Project Name: Town of Hillsborough, Utilities Department
Adron F. Thompson Addition and Renovation
Project No.: 2231.01

ADDENDUM No. 3

Issued January 21, 2026

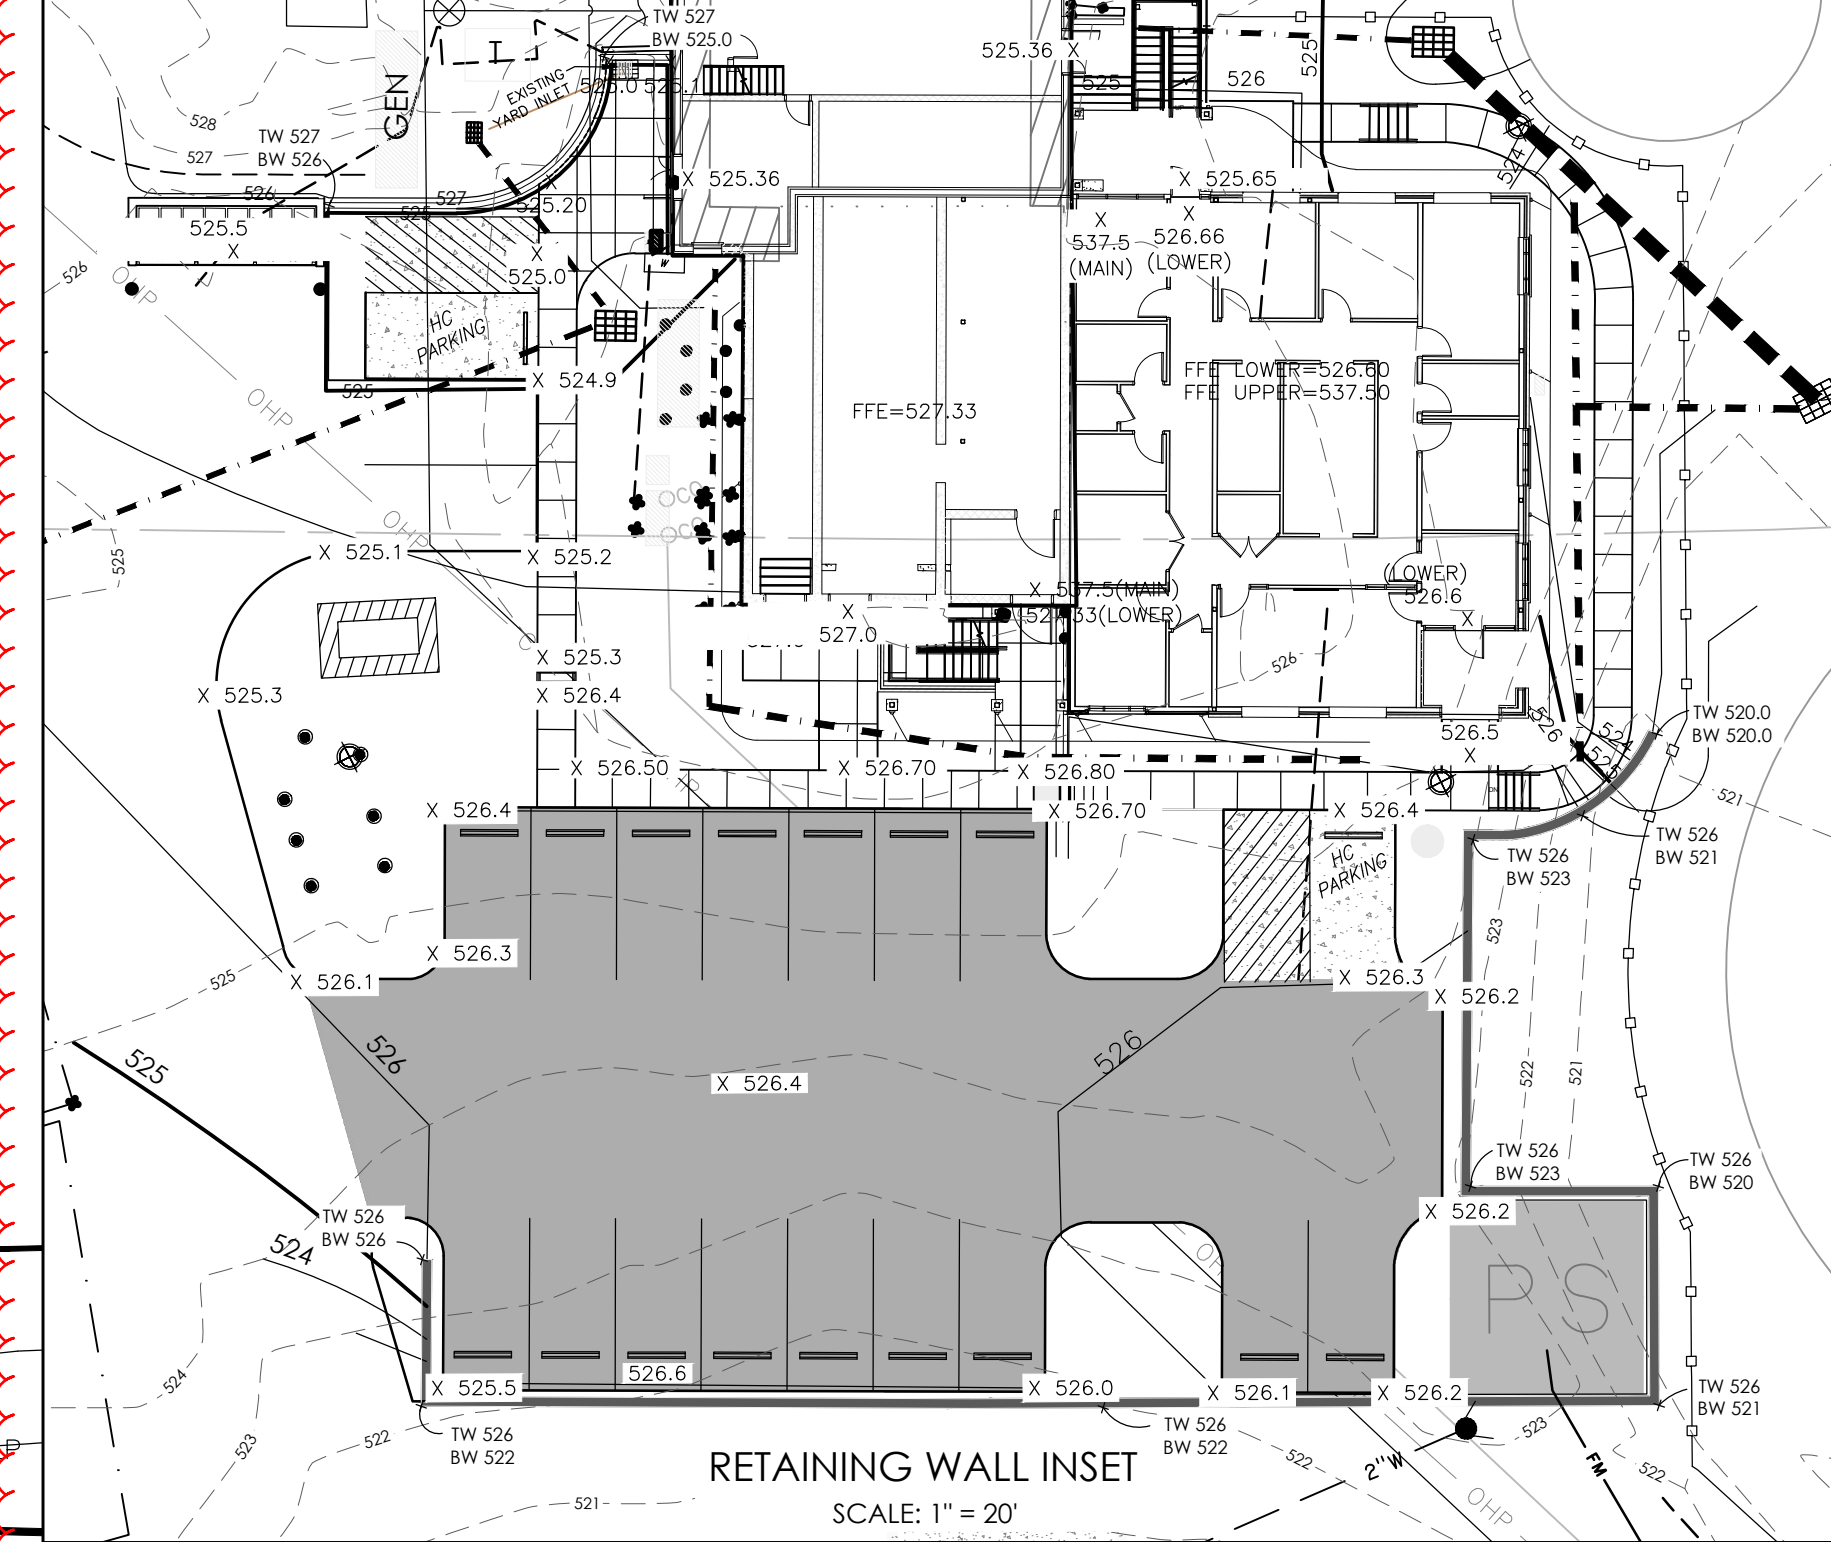
4. Replace plan sheet number **C-2.0 SITE LAYOUT** with the attached sheet of the same number. Sheet was modified to remove the note that indicated "PROPOSED RETAINING WALL" at the Northwest corner of the Vehicle Storage Building. Clouded area indicates removed text location. Other minor revisions were made for this sheet to match the architectural plans for the sidewalk layout around the building and the curved retaining wall at the Lower Level Entrance of Original Building.

1 ADDITION & RENOVATION PLAN - MAIN LEVEL
A202 1/4" = 1'-0"

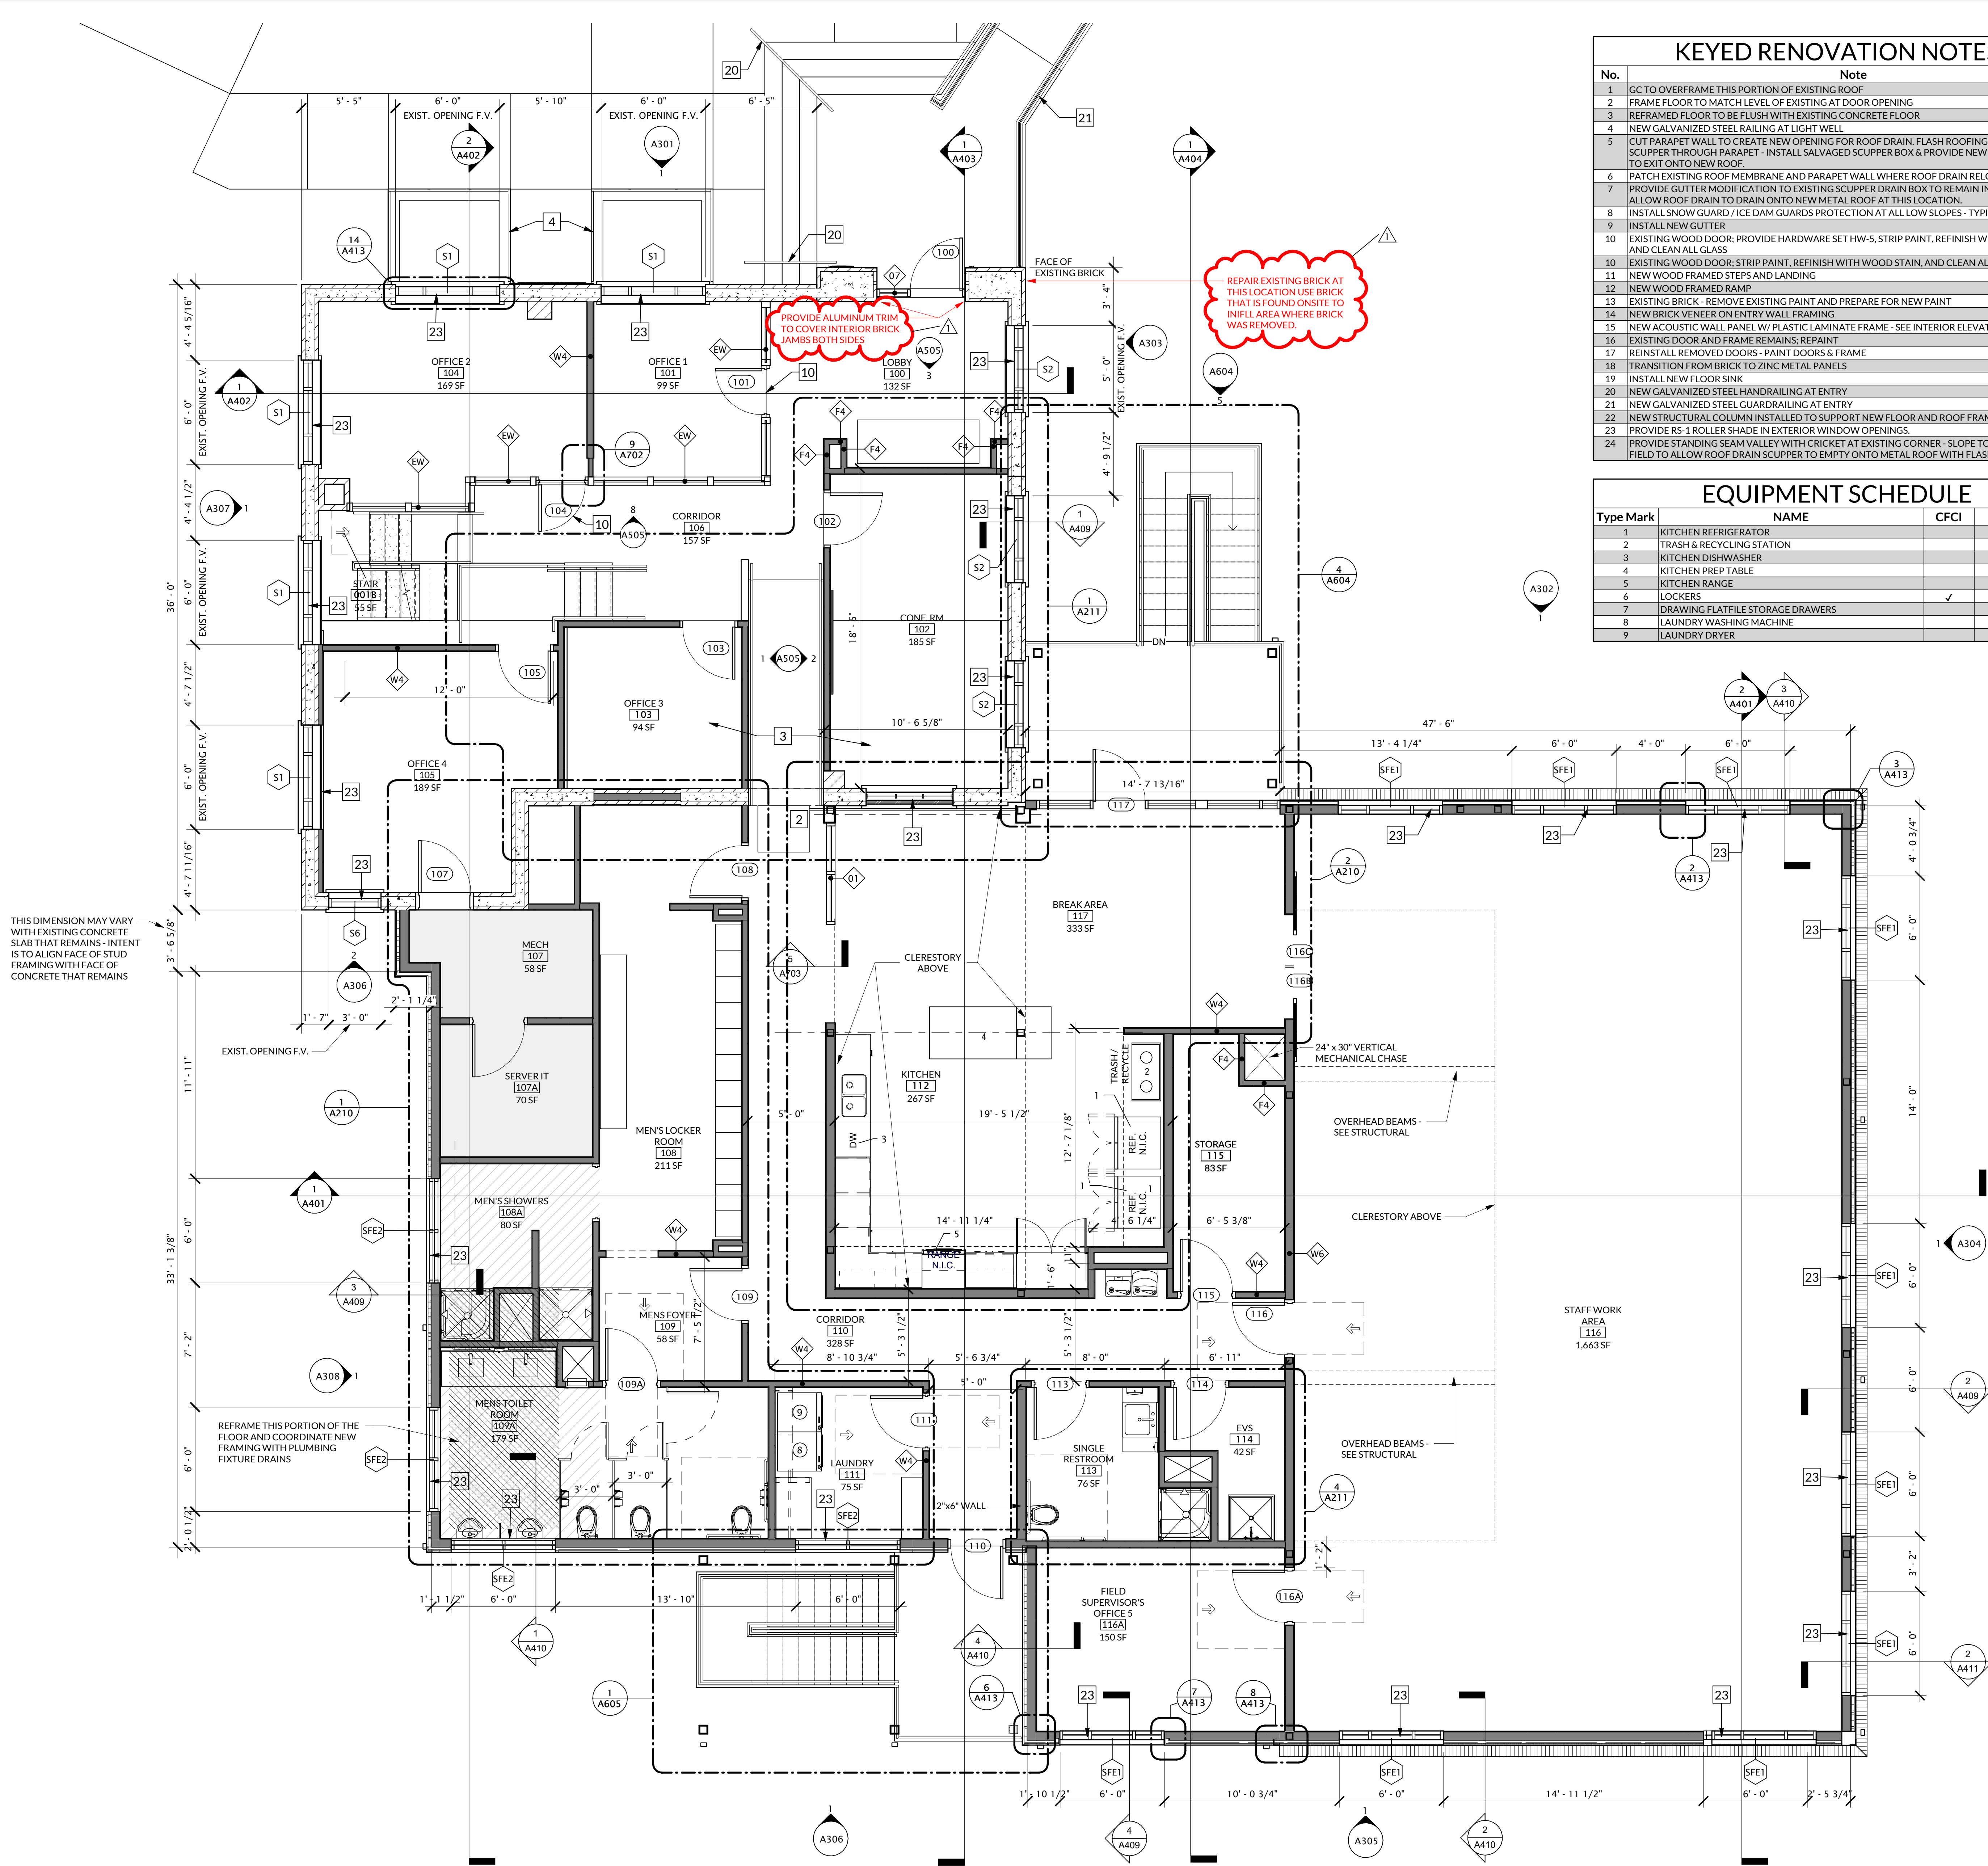
7. Replace sheet number **A202 RENOVATION ADDITION PLAN - MAIN LEVEL** with the attached sheet of the same number. Sheet was modified to;
 - d. Add a note to include additional scope to install aluminum trim at both sides of interior brick jambs of Door 100 at Entrance Lobby 100.

- e. Add Note to direct the scope to repair brick at foundation with existing brick found onsite. See images below.
8. Replace sheet number **E001 ELECTRICAL LEGEND AND NOTES** with the attached sheet of the same number. Sheet was modified to add Flag Pole Lights to the fixture schedule.

1 Electrical Renovation Plan - Lower Level
SCALE: 1/4" = 1'-0"

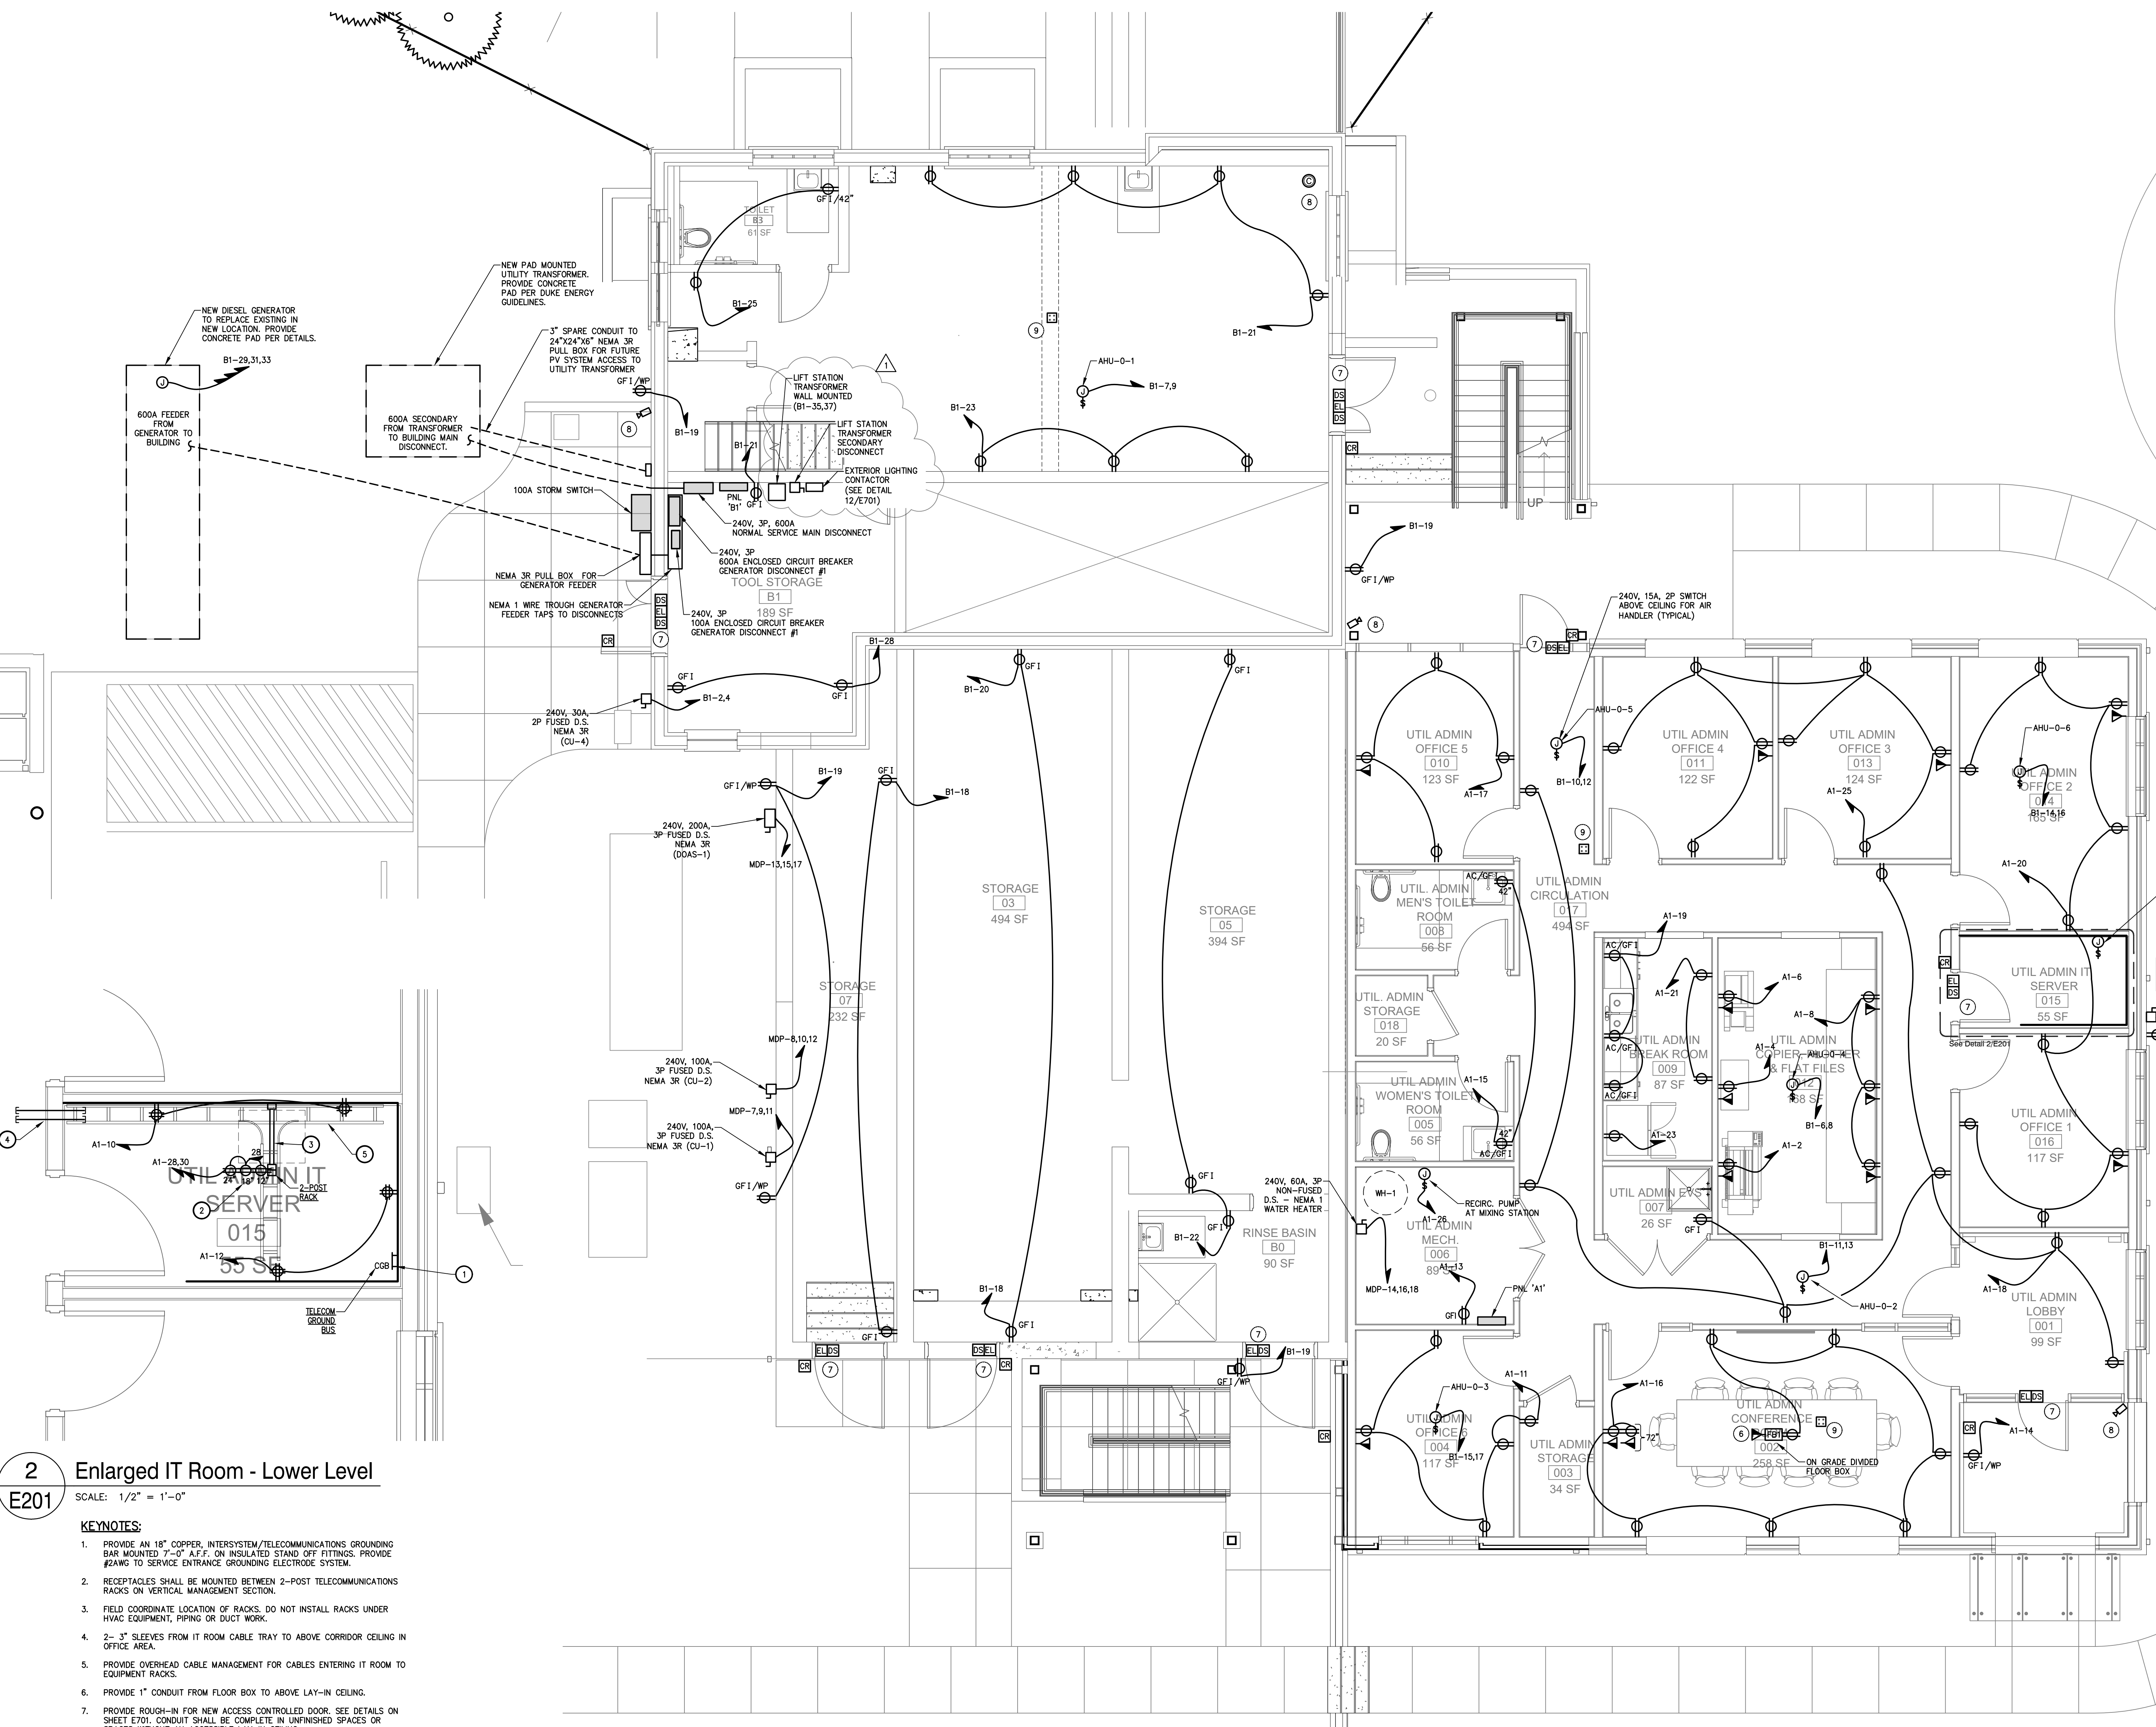
9. Replace sheet number **E201 ELECTRICAL RENOVATION PLAN - LOWER LEVEL** with the attached sheet of the same number. Sheet revised to add step-up transformer & disconnect switch for pump station; and show exterior lighting contactor location in main electrical room.
